BGRR-015, Rev. 0

Brookhaven Graphite Research Reactor Decommissioning Project

Removal Action Alternatives Study

April 13, 2000

PLAN VIEW OF BLDG 701 AND BLDG 702

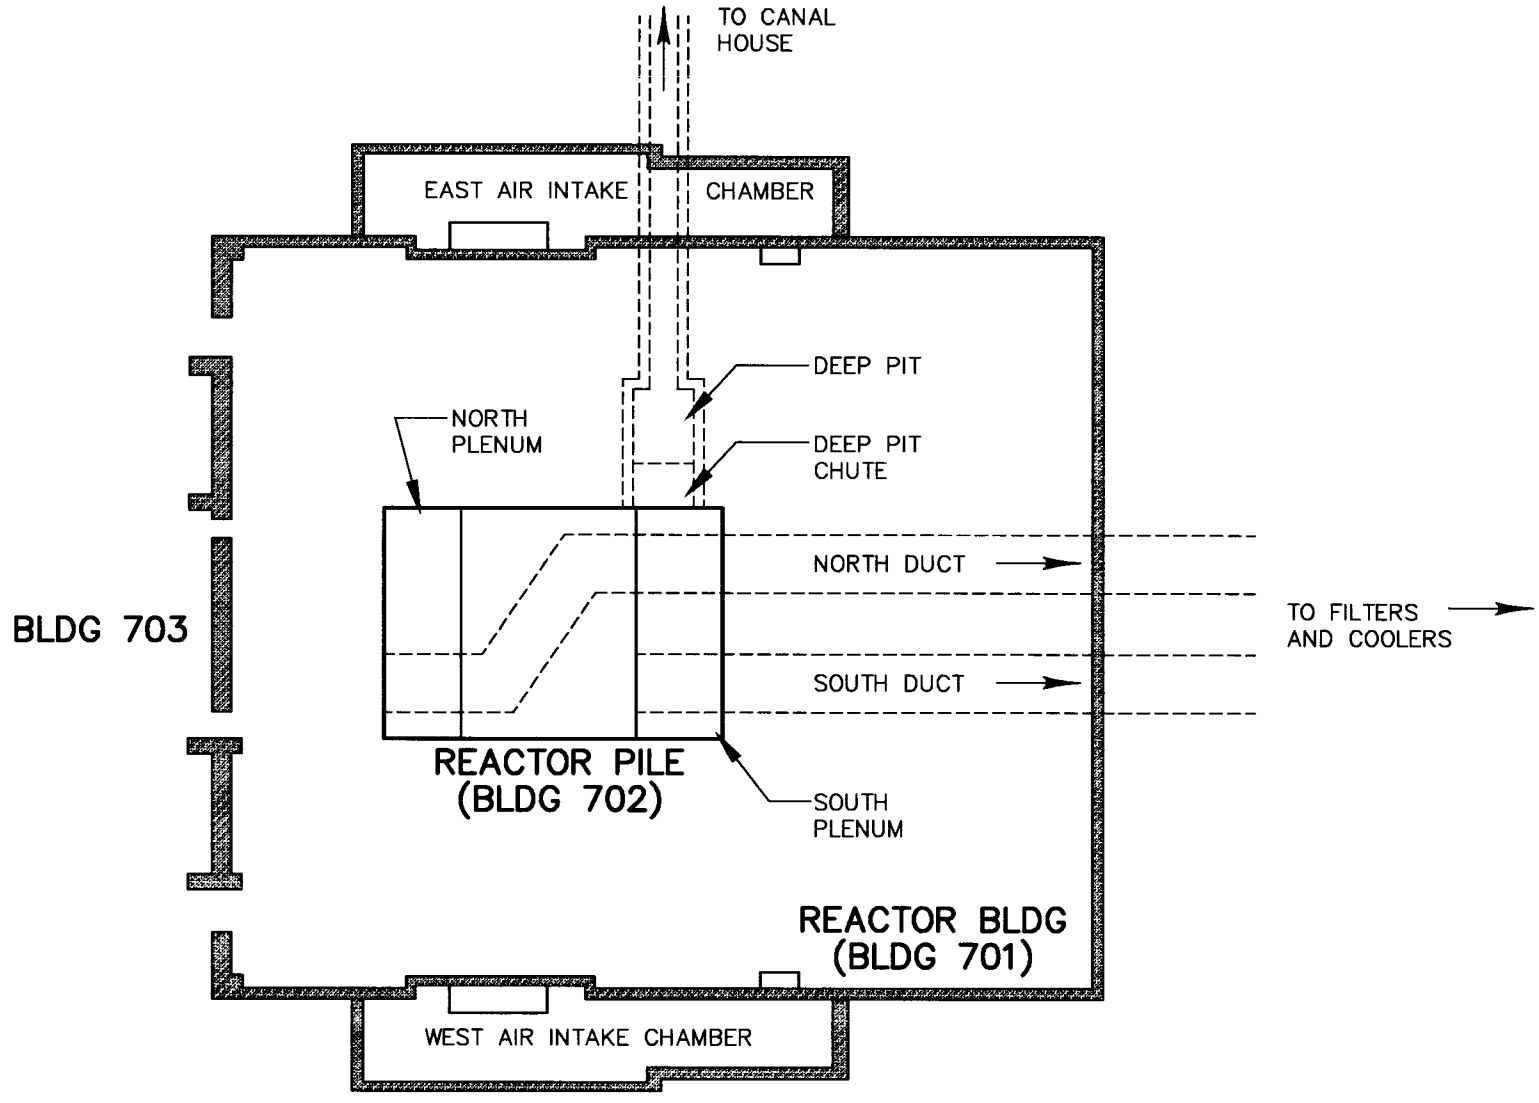
Figure 1-3 This figure should have North on the top as per convention and as done in most other figures in the document	These tables and figures are in a format that cannot be modified in the time than remains before the RAAS is due.

PLAN VIEW OF REACTOR PILE

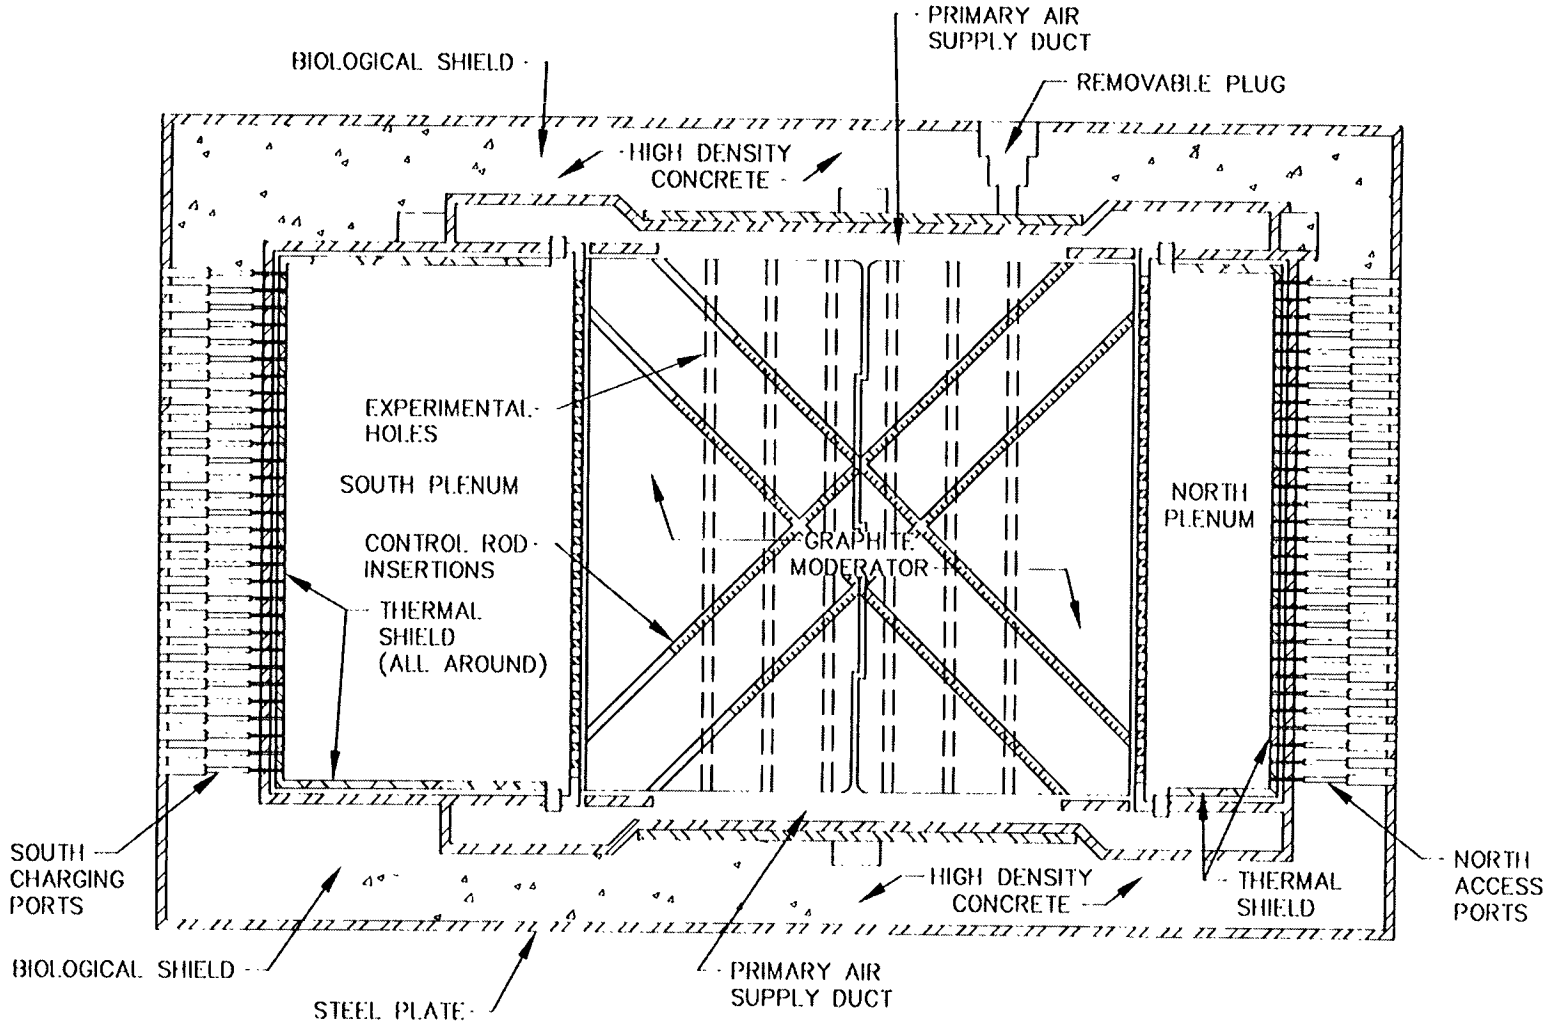
p. 1-13 Graphite also reflected the neutrons	Yes, that is true.
Figure 1-5 North should be at top	These tables and figures are in a format that cannot be modified in the time than remains before the RAAS is due.

SECONDARY AIR COOLING SYSTEM IN EXTERIOR PRIMARY AIR EXHAUST DUCT DIAGRAM

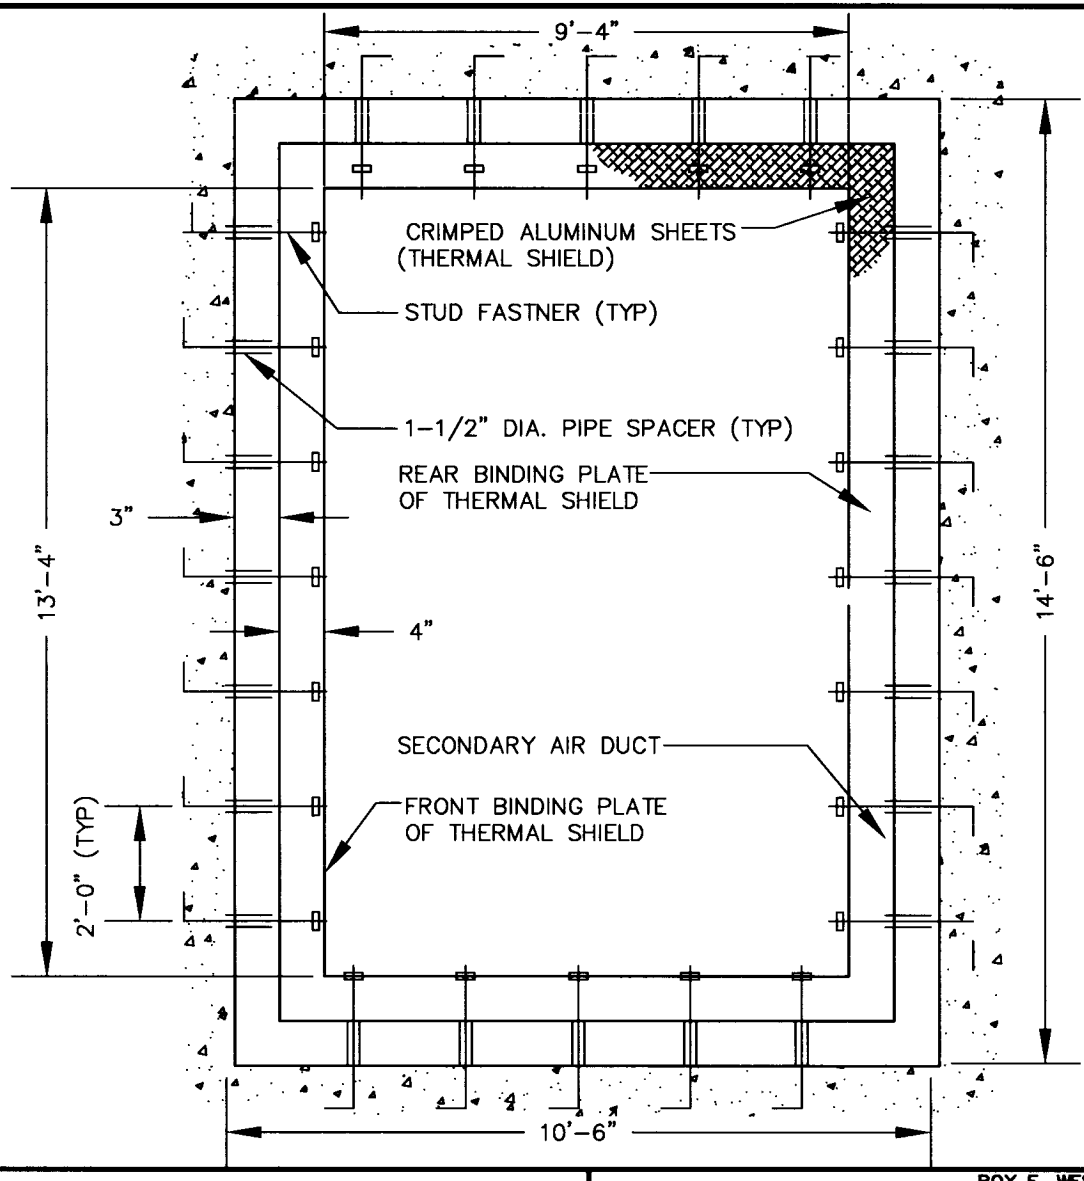
p. 1-17 Isn't there a more recent report. Perhaps Meinhold -1999	At the time the RAAS was prepared, Meinhold - 1999 had not been approved.
Figure 1-9 Arrow for rear binding plate ends in air duct. Shouldn't it be at plate?	These tables and figures are in a format that cannot be modified in the time than remains before the RAAS is due.

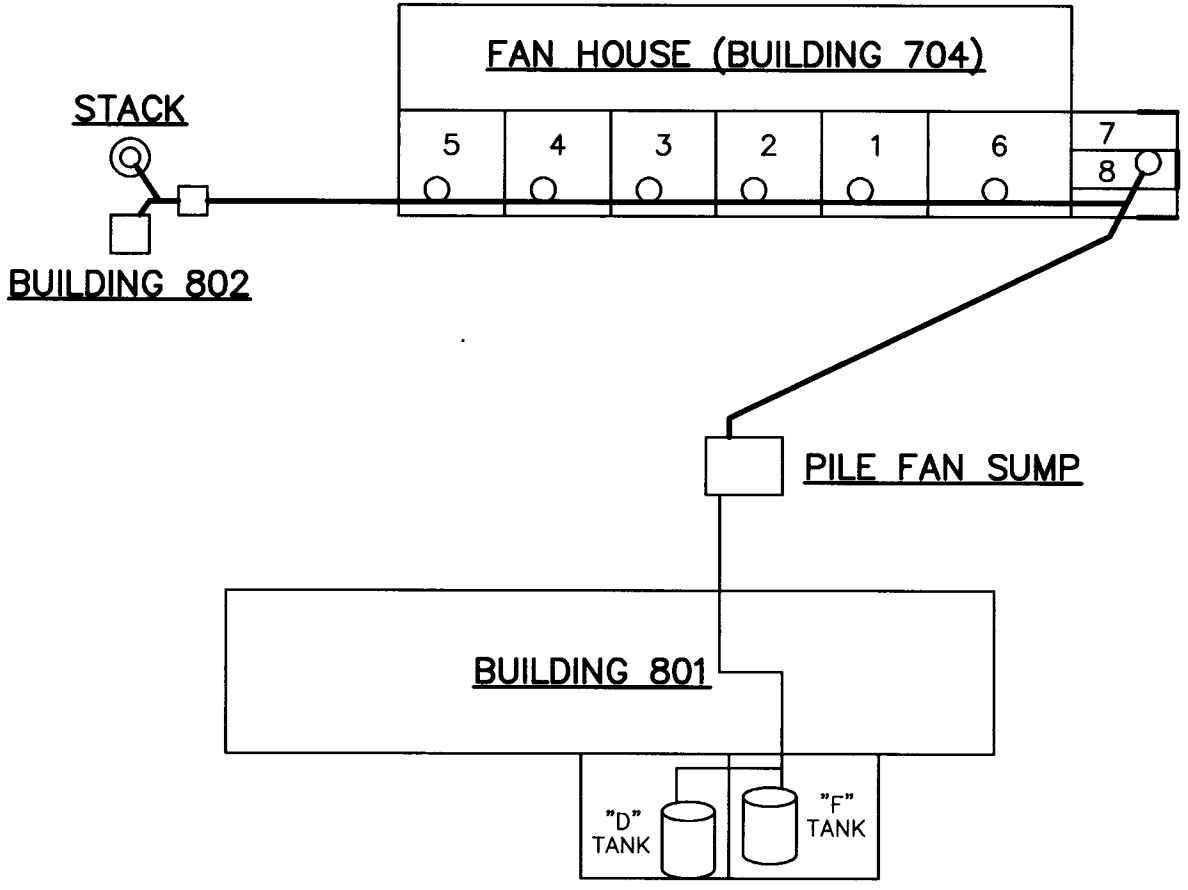
p. 1-37 Needs capital S (on Radioactive Material Area Survey)	Corrected.
Figure 1-15 If this is meant to be a "map" type figure, should have North at the top.	This is a sketch of the floor drain system, not a map.
Figure 1-15 If not, there should be a North arrow, which points DOWN, as opposed to the convention of having North at the top. Building 801 is north of the fan house, the stack is East of the fan house and 802 is north of stack in other diagrams (maps).	These tables and figures are in a format that cannot be modified in the time than remains before the RAAS is due.

Figure 2-2

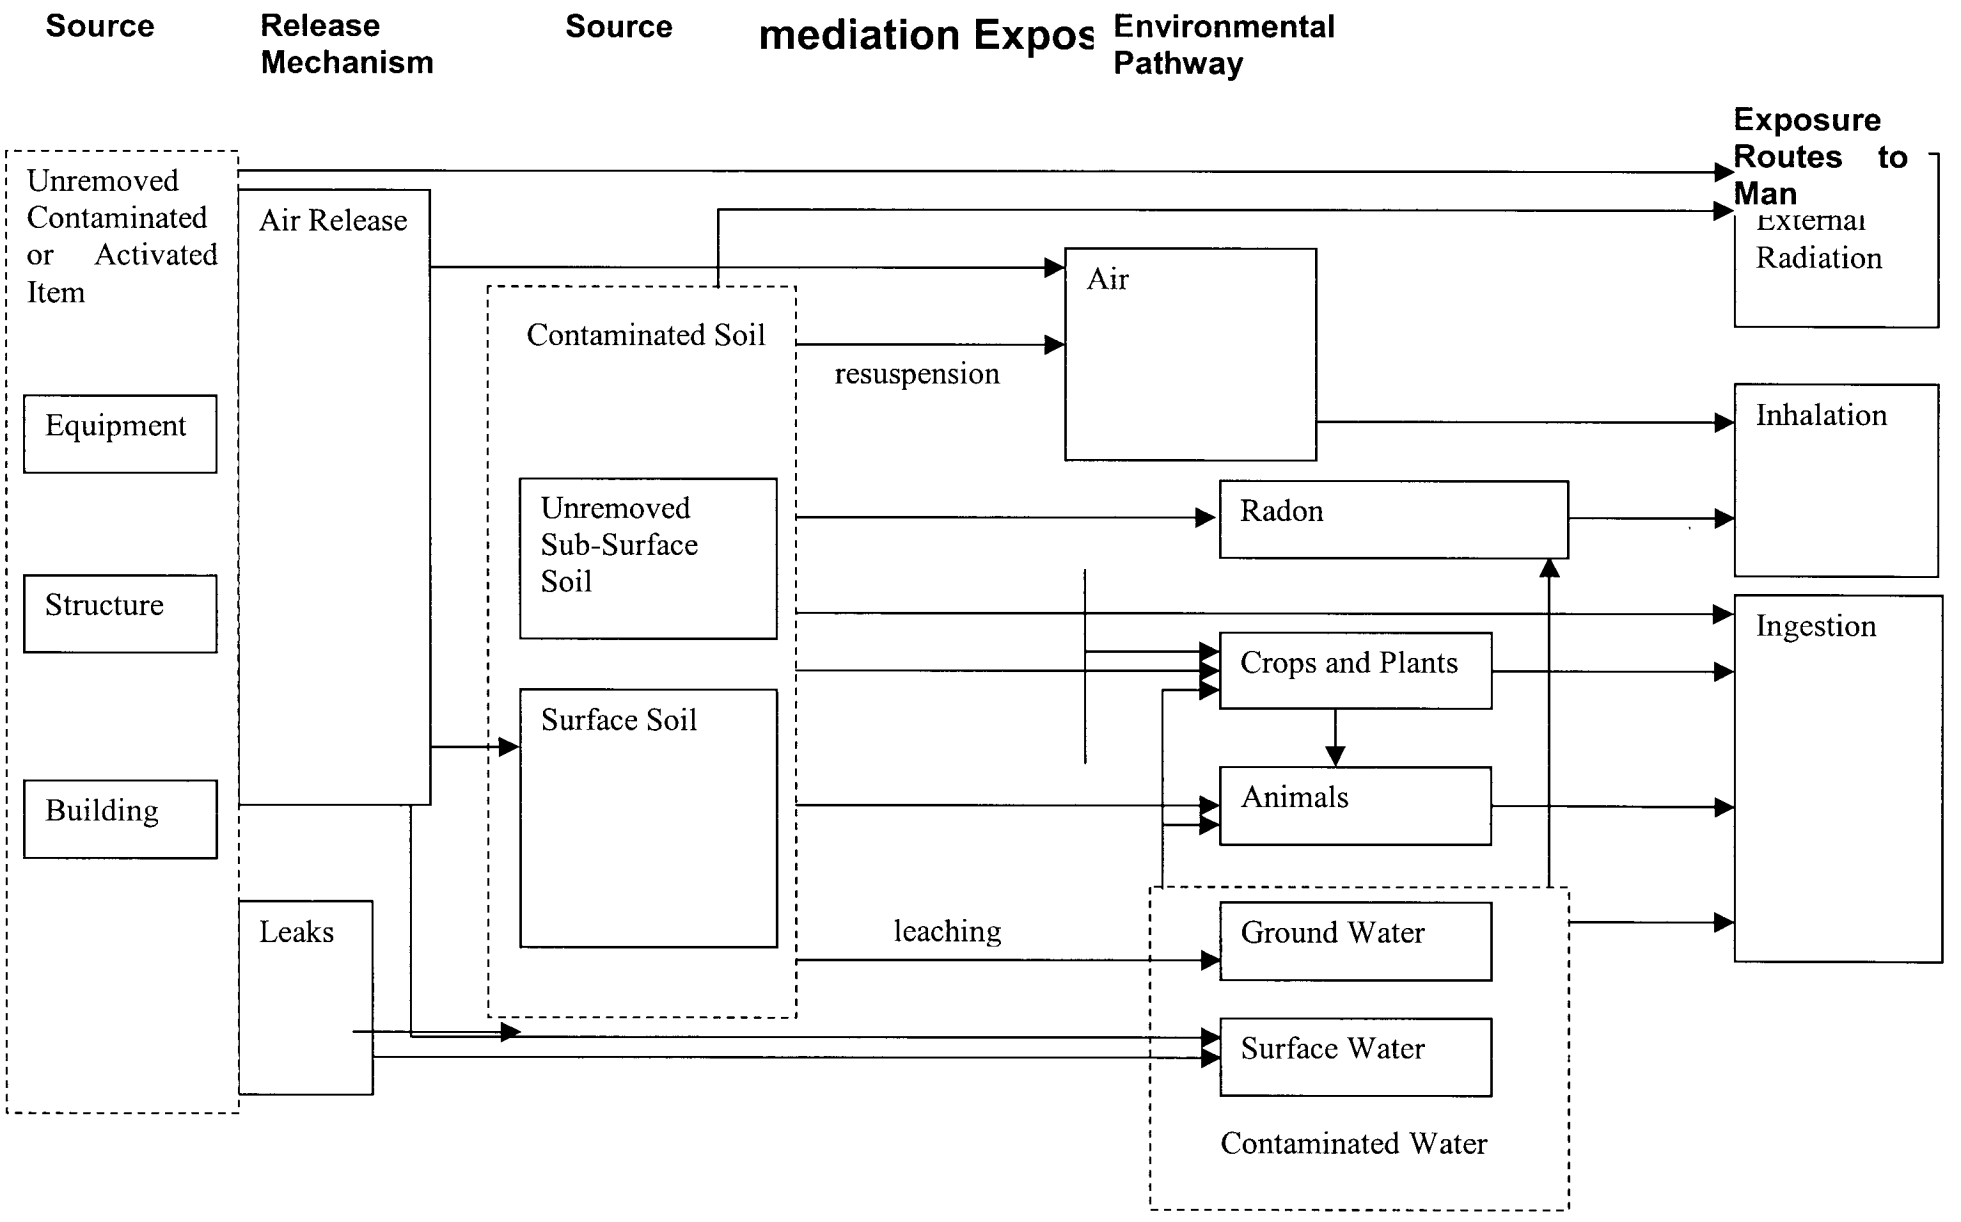
p. 2-3 Add to sentence "and environments" as per the phrasing used on following pages. [last sentence of the second bullet point]	Added.
p. 2-4 Add ingestion of H20 as per figure 2-2	Yes, ingestion of water should be added to this list.
Figure 2-2 Add ingestion of H20 ????	It is already included. Box containing ground water and surface water includes an arrow to the ingestion exposure route.
